**2019 SMP PACKAGE I
(AVENIDA PRIMA, LA AVENTURA, & LA BAHIA)
Solicitation Number: CO-00201
Job No.: 18-5008 and 18-5508**

**ADDENDUM NO. 1
August 14, 2018**

| MAP No. 192624 AND 192626 | SHEET 8 |

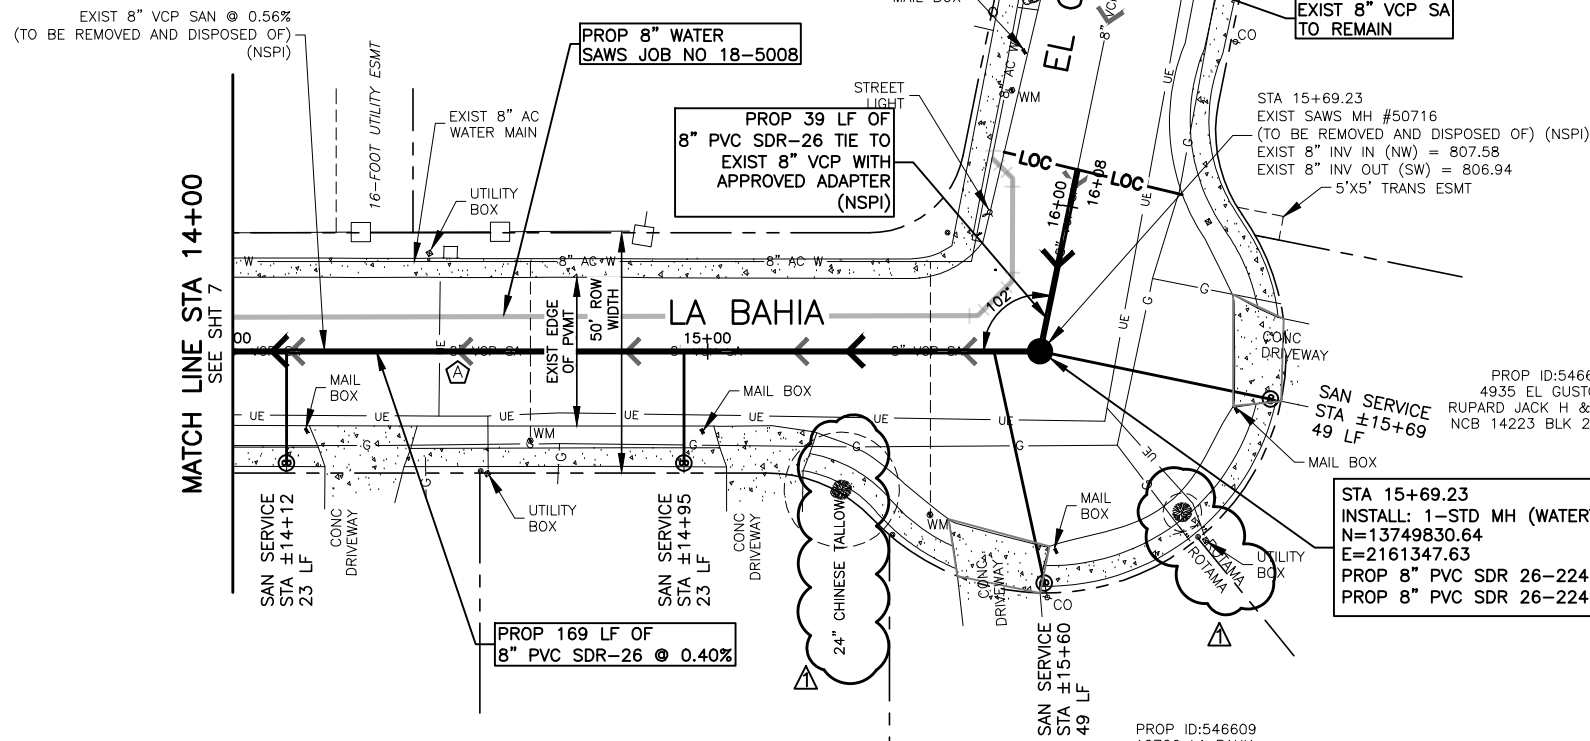
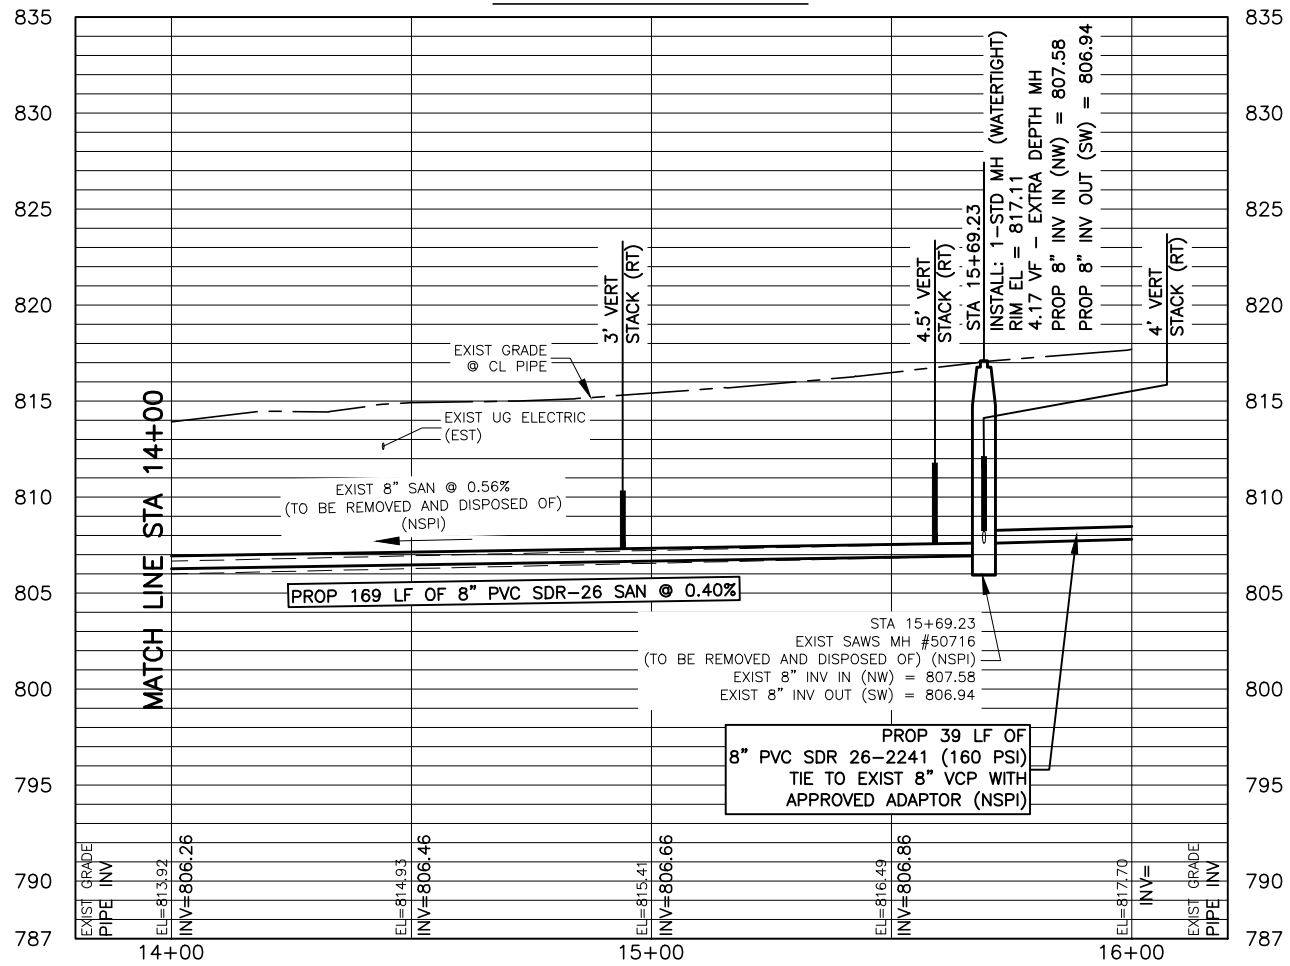
- 1. DELETE Sheet 8 of 14 of the SEWER PLANS in its entirety and REPLACE with the attached Sheet 8 of 14, dated 7/27/18. Sheet 8 has been revised to show updated tree species and/or location.**

MAP No. 192624 AND 192626 SHEET 9 OF 14
SECT. No.
DR. CK. JOB No. 18-5508

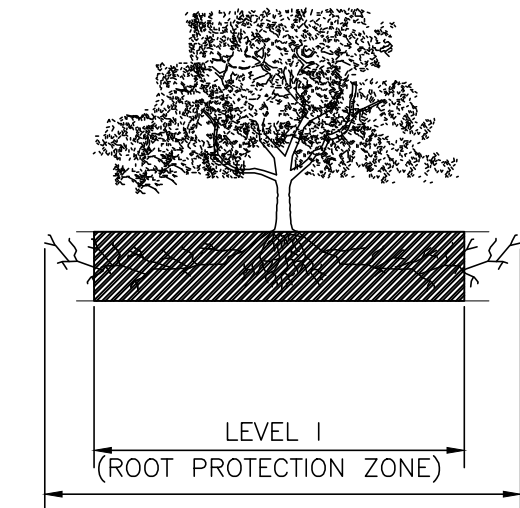
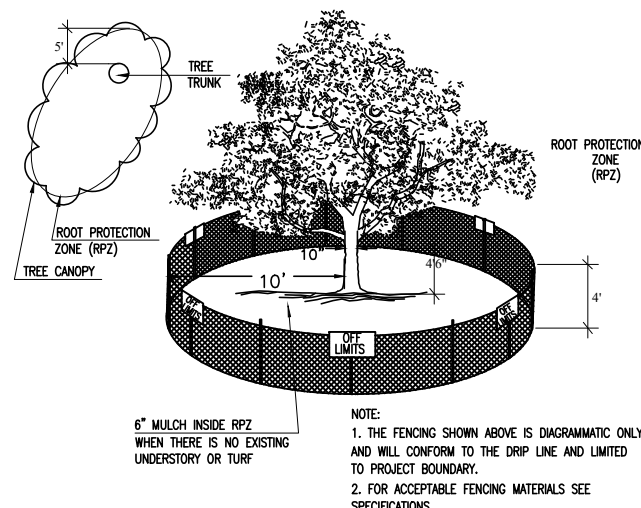
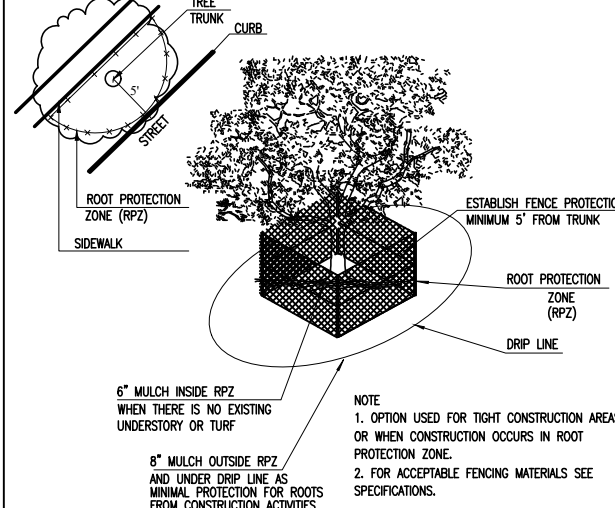
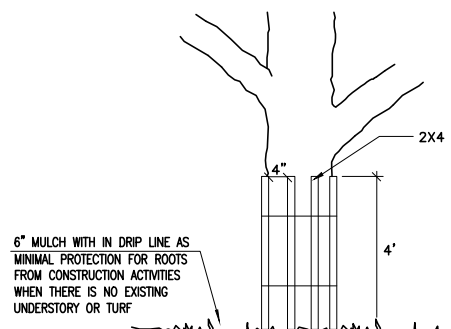
- 2. DELETE Sheet 9 of 14 of the SEWER PLANS in its entirety and REPLACE with the attached Sheet 9 of 14, dated 7/27/18. Sheet 9 has been revised to show updated tree protection table and tree general note 13.**

| SUBMITTED _____ | SHEET 14 |

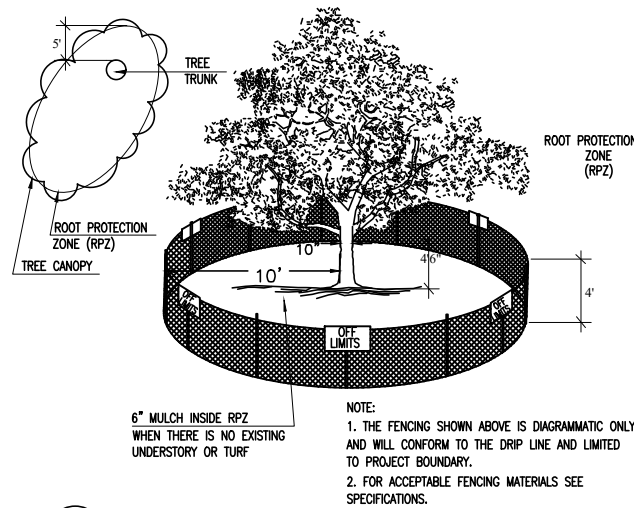
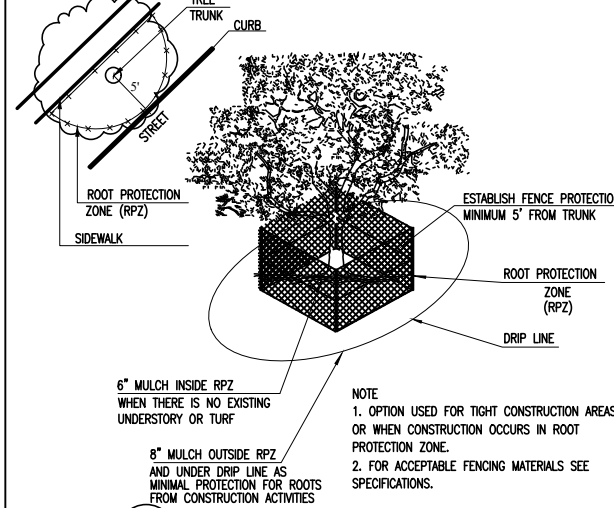
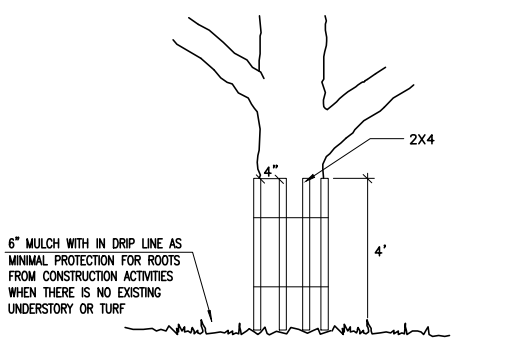
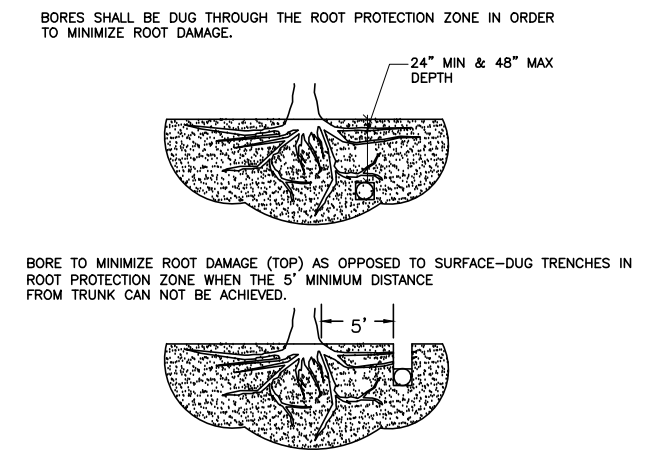
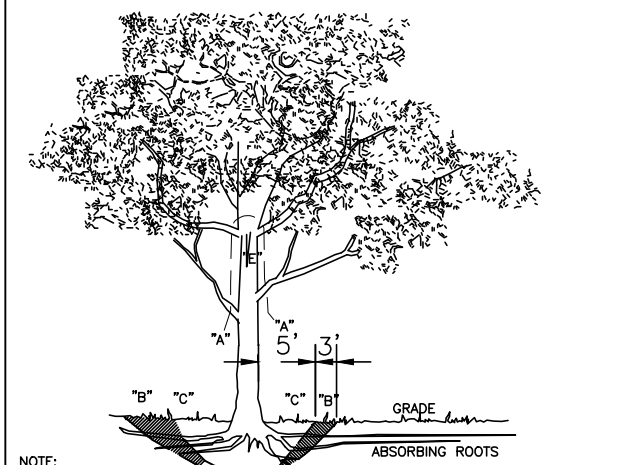
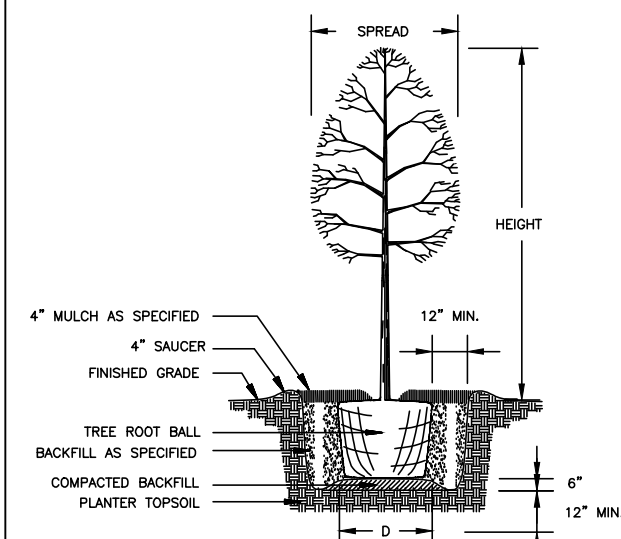
- 3. DELETE Sheet 14 of 14 of the SEWER PLANS in its entirety and REPLACE with the attached Sheet 14 of 14, dated 7/27/18. Sheet 14 has been revised to show updated tree protection table and tree general note 13.**

MAP No. 192624 AND 192626
SECT. No. _____
DR. CK. JOB No. 18-5008 SHEET 9 OF 29

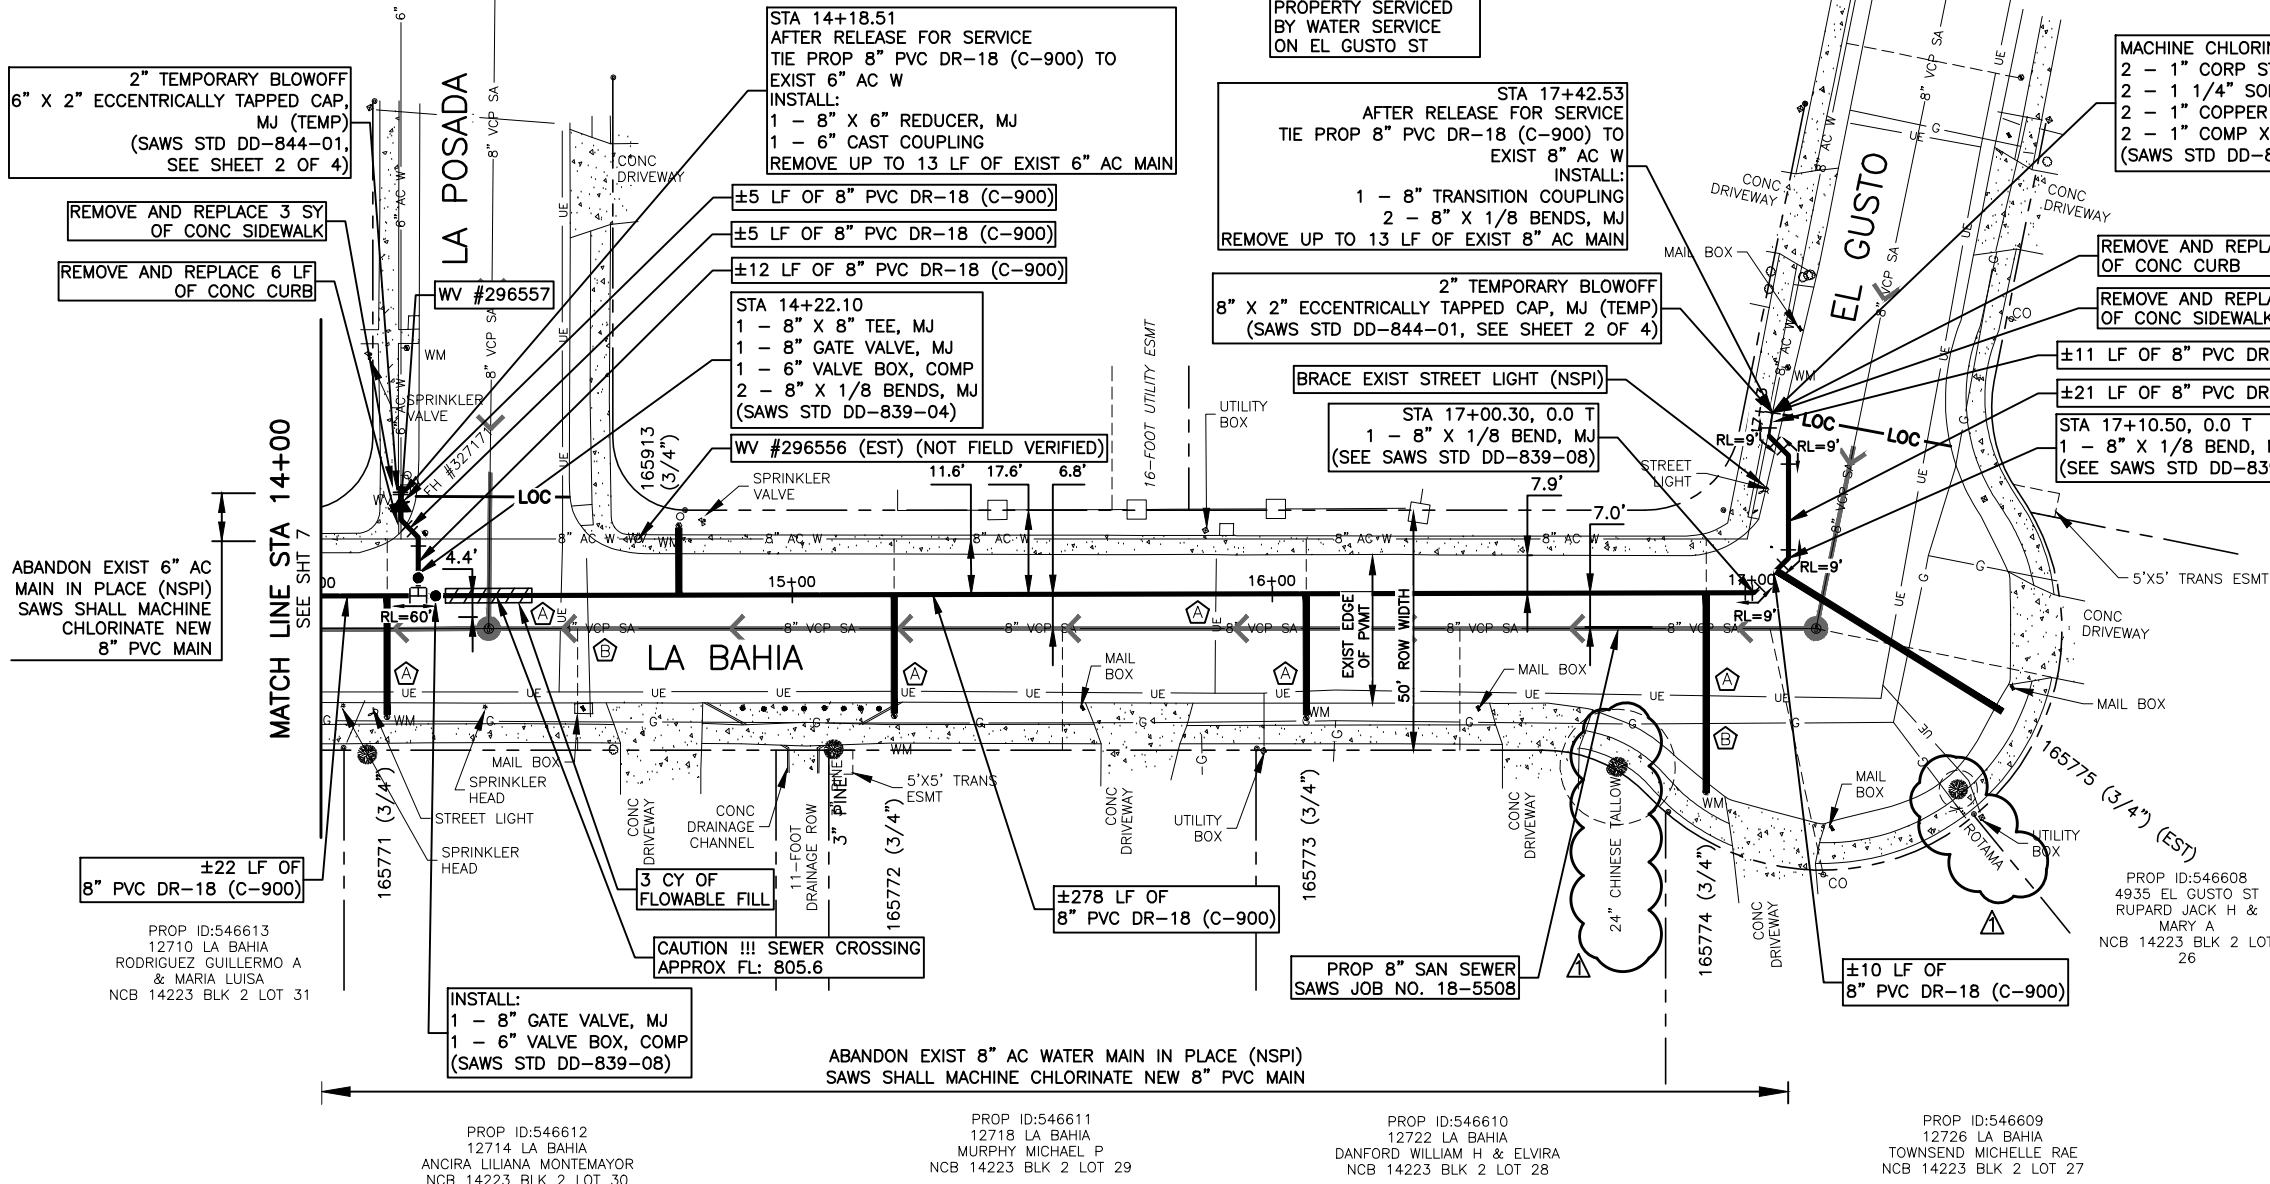
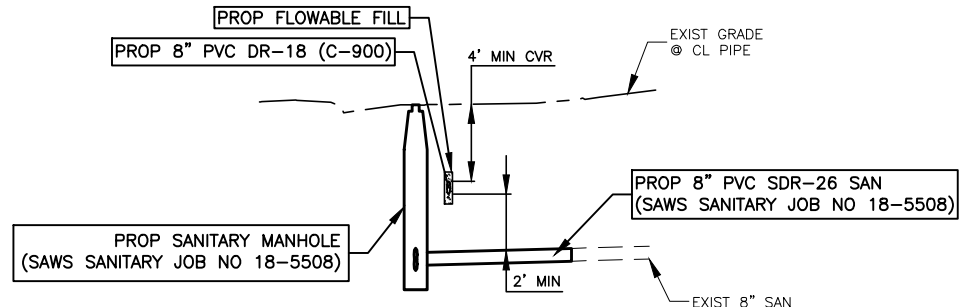
- 4. DELETE Sheet 9 of 29 of the WATER PLANS in its entirety and REPLACE with the attached Sheet 9 of 29, dated 7/27/18. Sheet 9 has been revised to show updated tree species and/or location.**

MAP No. 192624 AND 192626 SHEET 10
SECT. No. _____ OF 29
DR. CK. JOB No. 18-5008

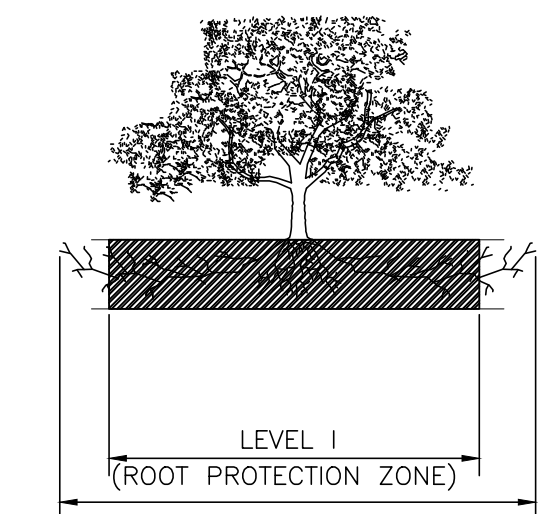
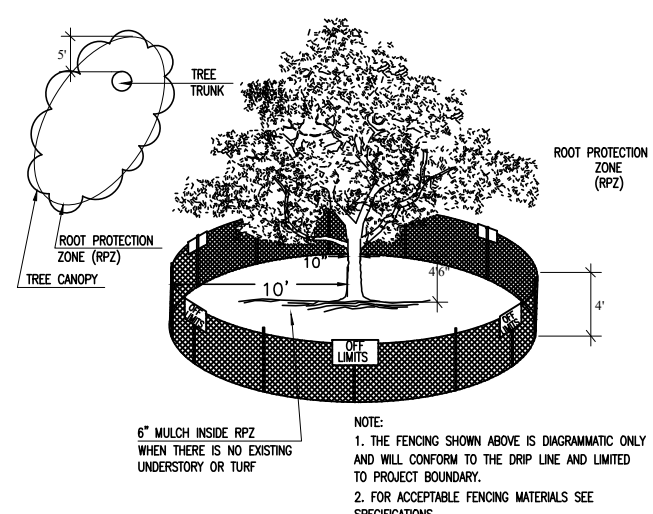
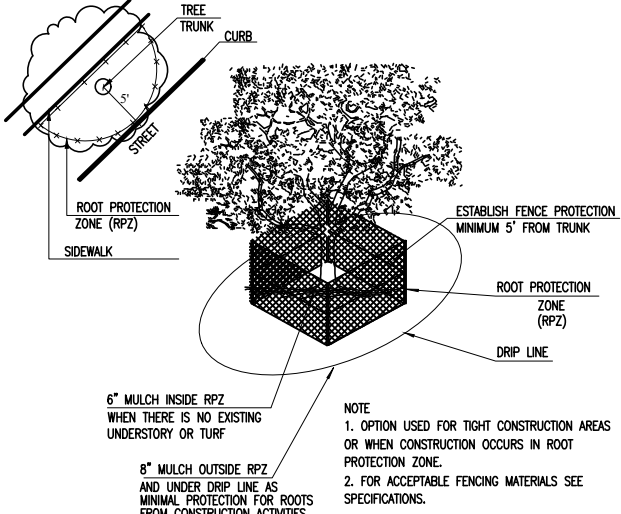
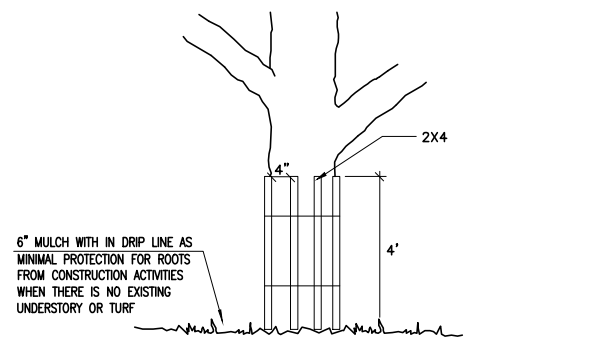
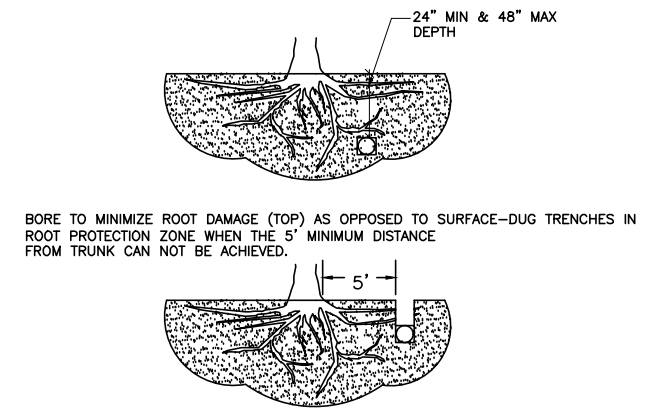
- 5. DELETE Sheet 10 of 29 of the WATER PLANS in its entirety and REPLACE with the attached Sheet 10 of 29, dated 7/27/18. Sheet 10 has been revised to show updated tree protection table and tree general note 13.**
